ADDENDUM NO. 1
Amelia River Waterfront Stabilization Parking Lots C & D
City of Fernandina Beach
Invitation to Bid # 21-06
Issued: May 25, 2021

III. Changes to Drawings: (See attached)

**BID SET
 ADD. #1**

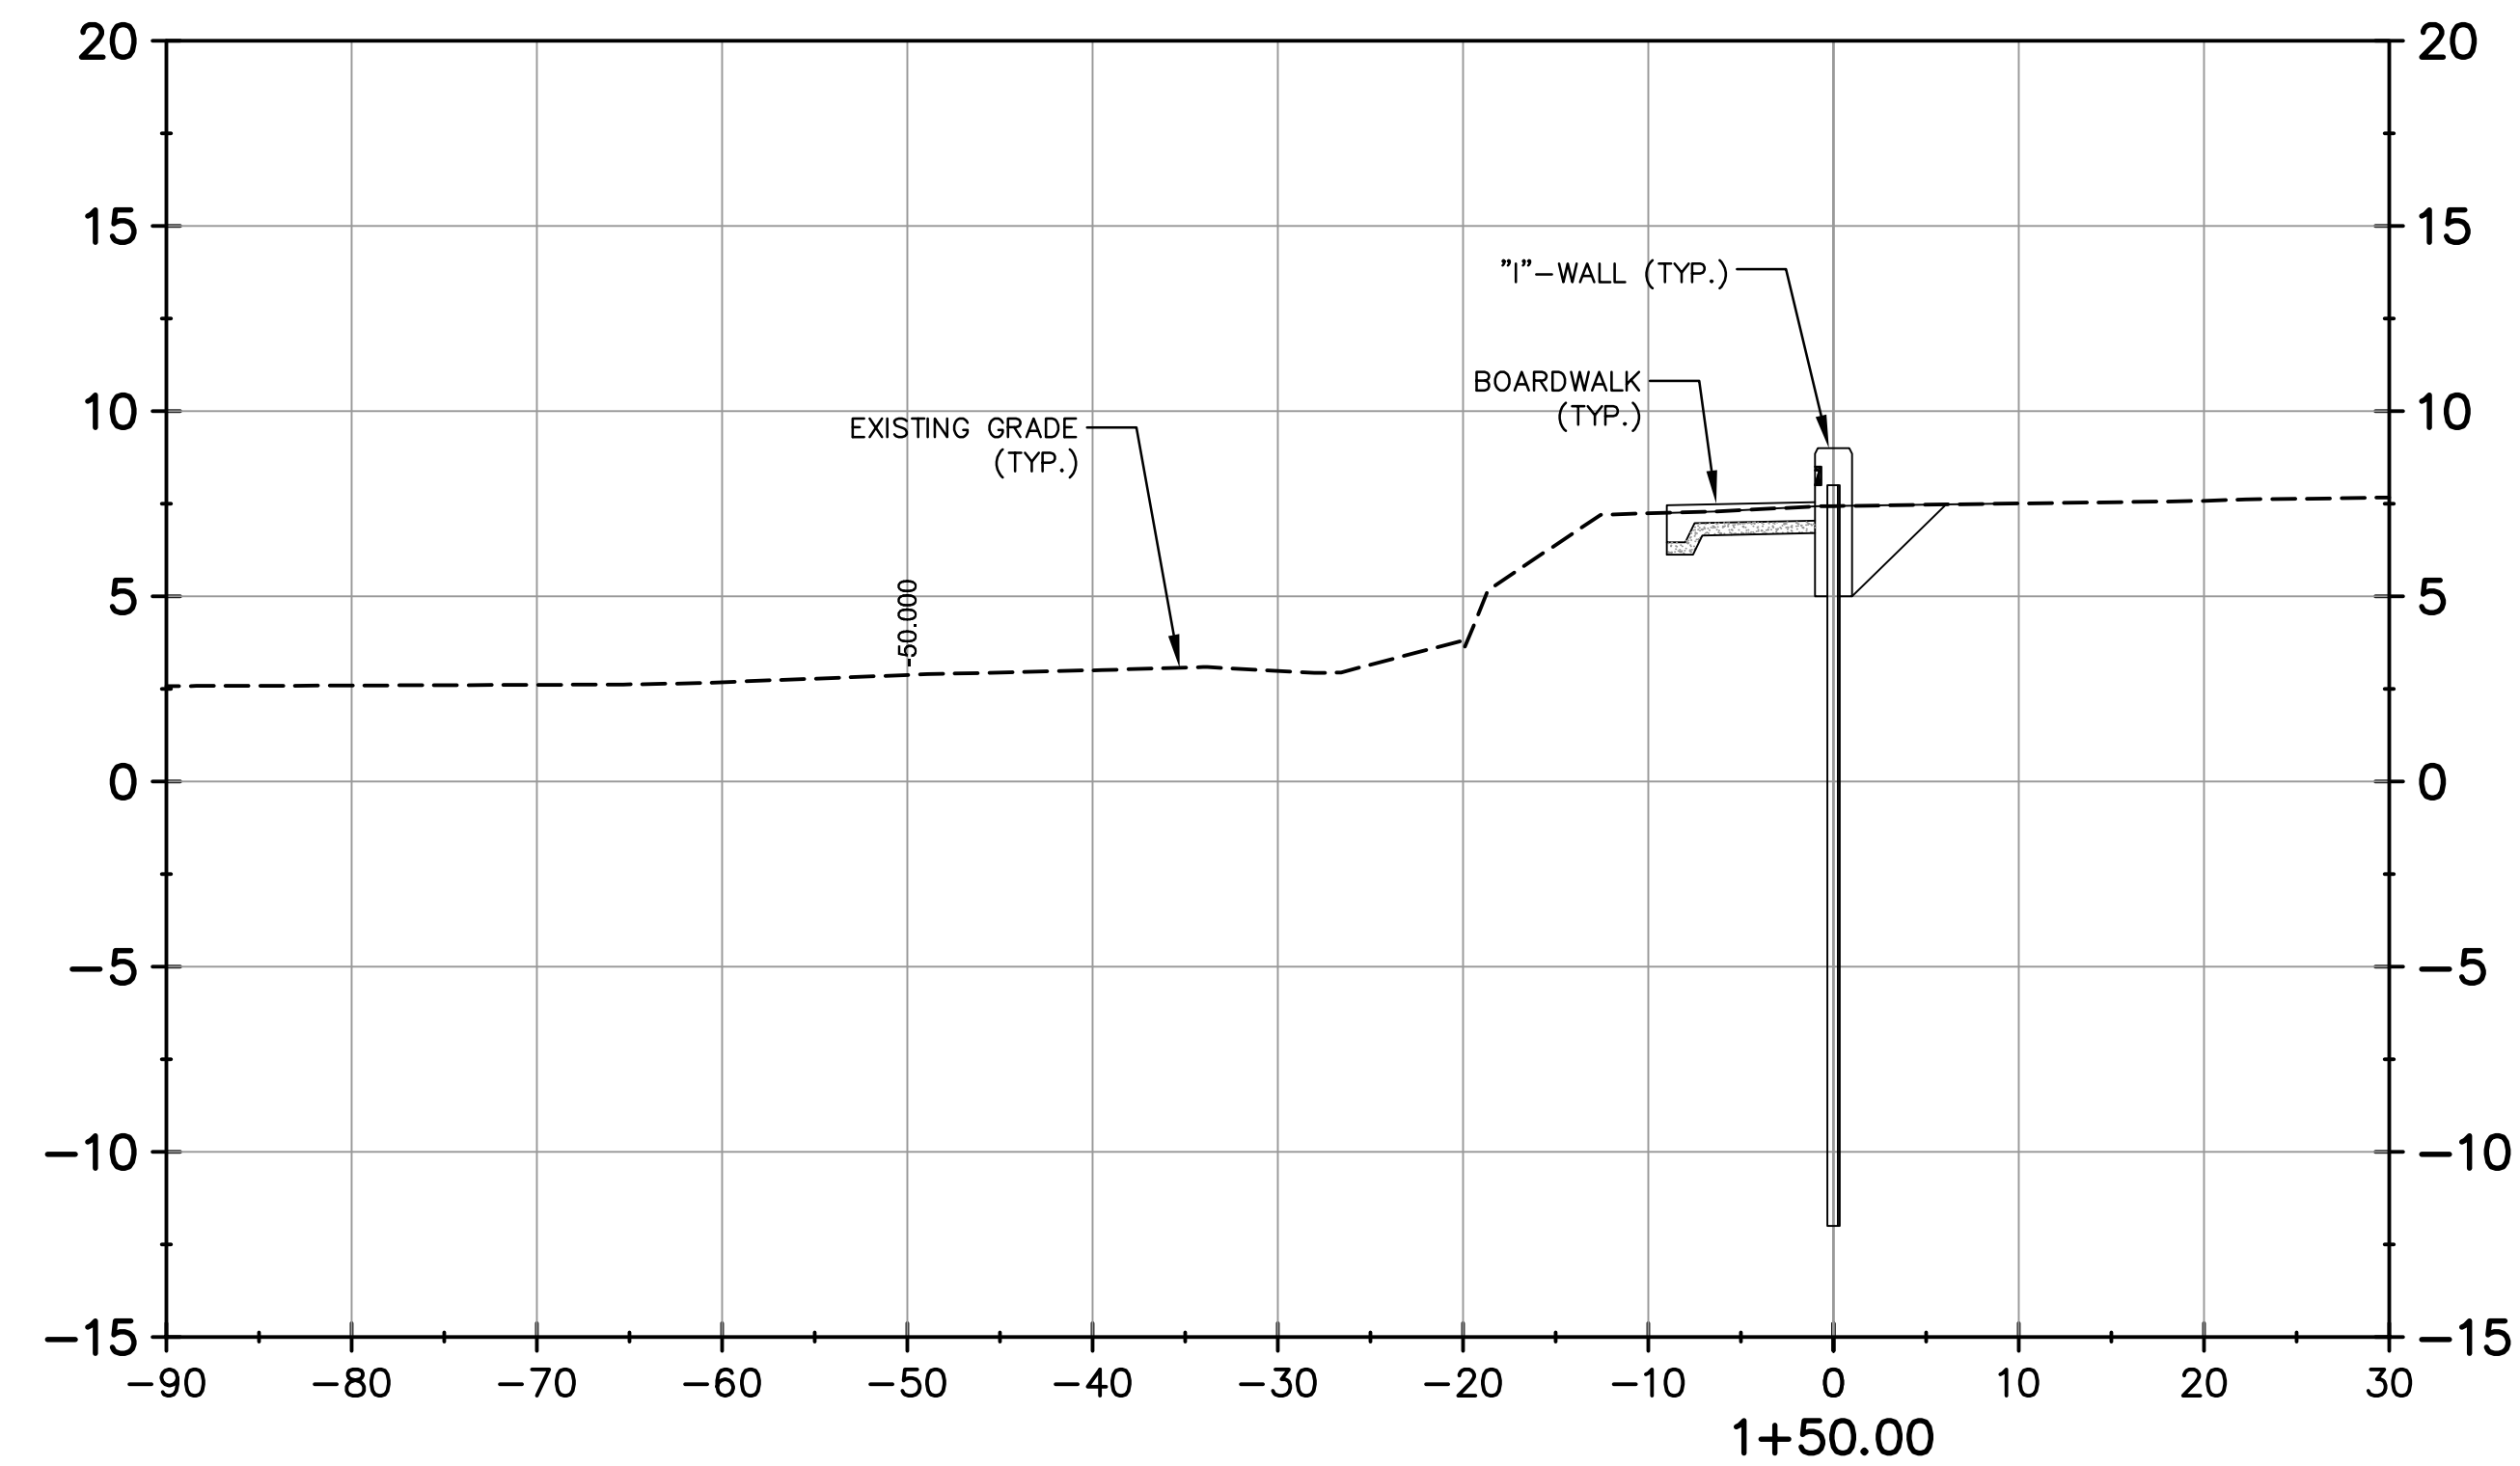
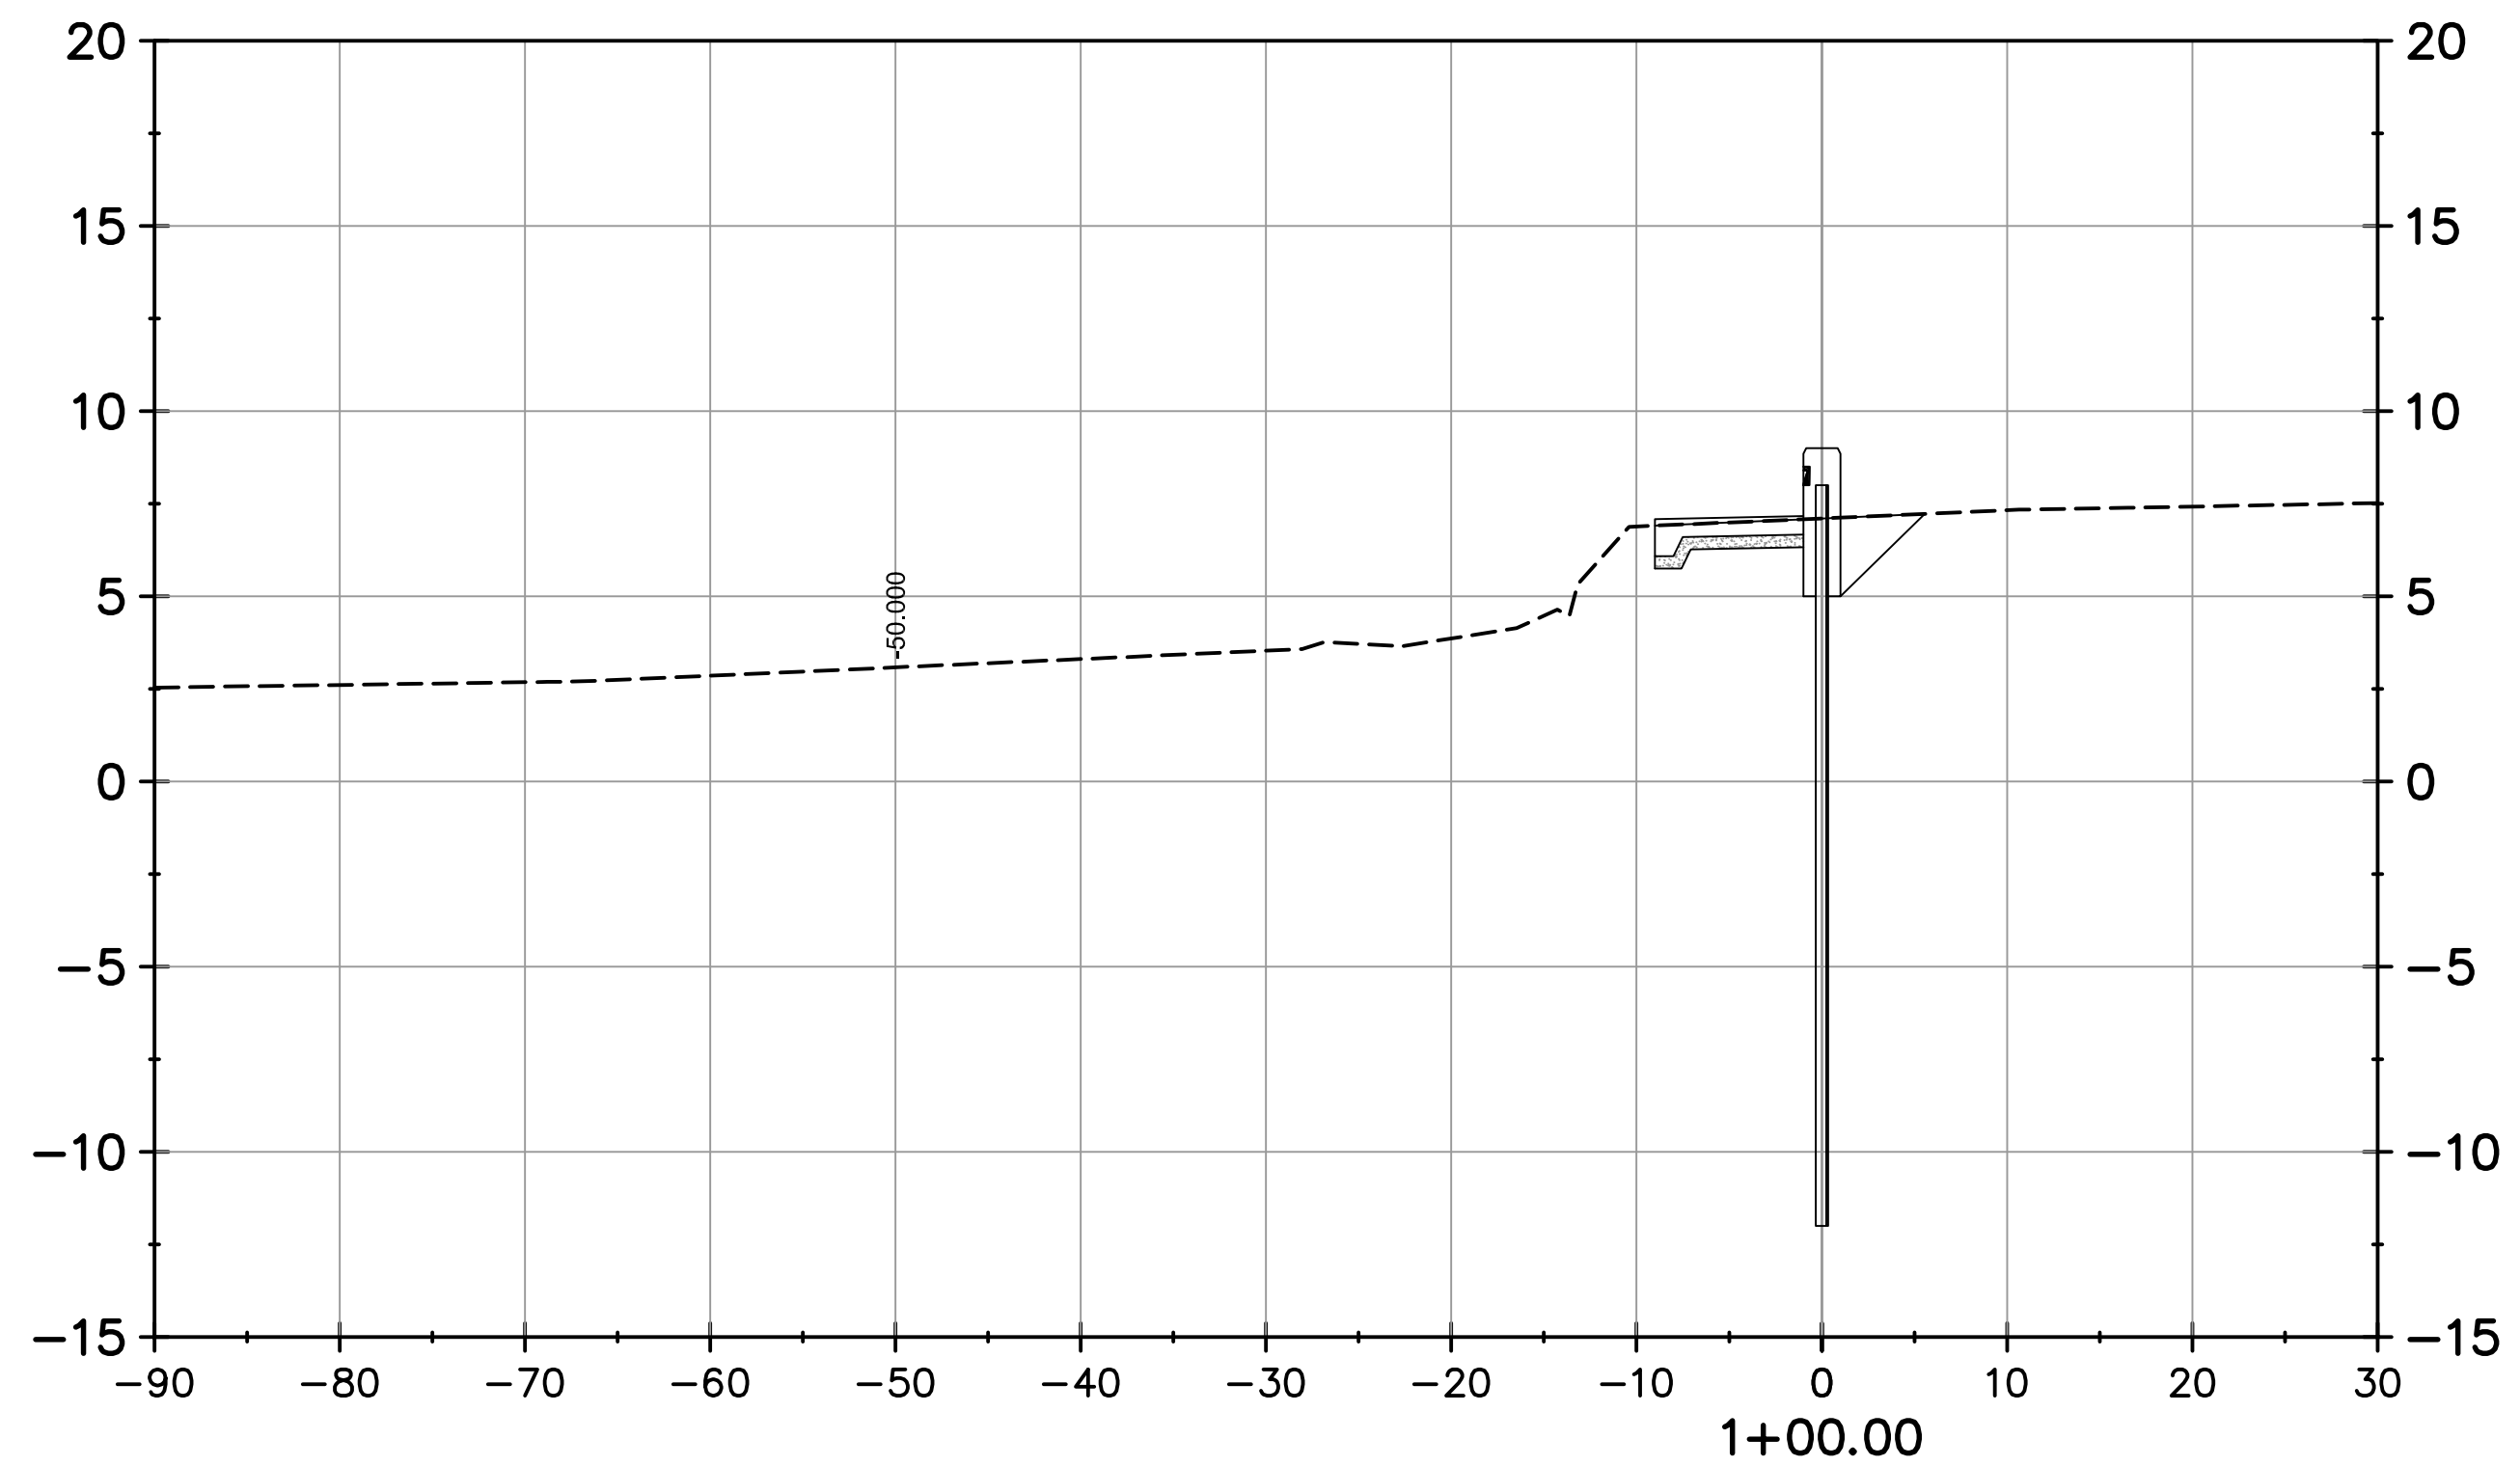
- 20) Sheet C6-1 - Revised I-Wall & Boardwalk Alignment and Cross Sections Adjusted.
- 21) Sheet C6-2 - Revised I-Wall & Boardwalk Alignment and Cross Sections Adjusted.

ALIGNMENT MOVED; CROSS SECTIONS ADJUSTED
